SURFACE WATER DRAINAGE – SUPPLEMENTARY REPORT LAND TO THE REAR OF SUNNYSIDE BARN AND FLINT BARN, BARNHAM

For Manorwood Ltd

Report Number: YE4281, Date: May 2020

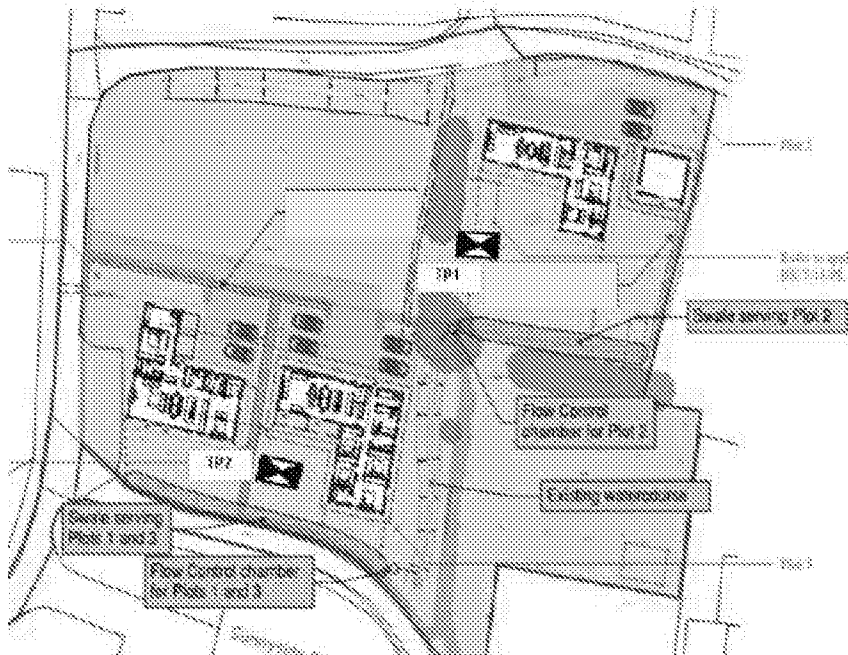
1. The groundwater level identified as part of the infiltration testing is unclear. The results state that each pit "filled 60cm within 20mins" from a starting point of 0.9mbgl and 0.7mbgl. On this basis we have read the results as peaking at 0.1mbgl in TP2. (Rather than both pits stabilising at 0.6mbgl). If this is the case the swales will require impermeable liners to avoid groundwater ingress, this will require the design to account for buoyancy. If the groundwater is in fact at 0.6mbgl then the applicant is advised to approach this department to discuss any further required monitoring and/or design options.

It is agreed that the data as presented could have been made more clear. During the excavation of the trial pit water ingress was noted at 0.9m bgl and was reported (verbally) to be perched groundwater which did not prevent the excavation from continuing to the target depth of 2.0m bgl. Once the excavation was complete water filled the excavation by 60cm (to 1.4mbgl) within 20mins. It is our contention that the design groundwater level is at 1.4m bgl (at TP1 and at TP2).

The Trial Pits were excavated in the positions shown below (not provided in the previous report). The ground levels at these locations are approx. 9.3m AOD for TP1 and approx. 9.1m AOD for TP2. Therefore, it may be stated that the groundwater level in TP1 has been measured at approx. 7.9m AOD at TP1 and at 7.7m AOD at TP2.

This would make sense as the watercourse which passes through the site has a bed level at between 8.2m AOD and 7.95m AOD. The lowest level being at the culvert which drains the site southwards. It would make sense that this watercourse prevents the groundwater from rising to the ground levels found across the site.
